SMITTYBILT TECHNICAL UPDATE

APPLICATION 07-15 JK 2 & 4 Door

PART NO. #76896 #76858, #76614

Fig A

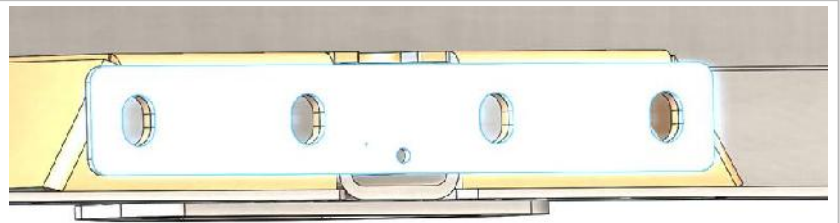
1. On some vehicles the center of the Gen 2 bumpers (on top) may come into contact with the body tub. (Fig A) or the corners
2. On some vehicles the corners of the Atlas may be too close to the body tub.
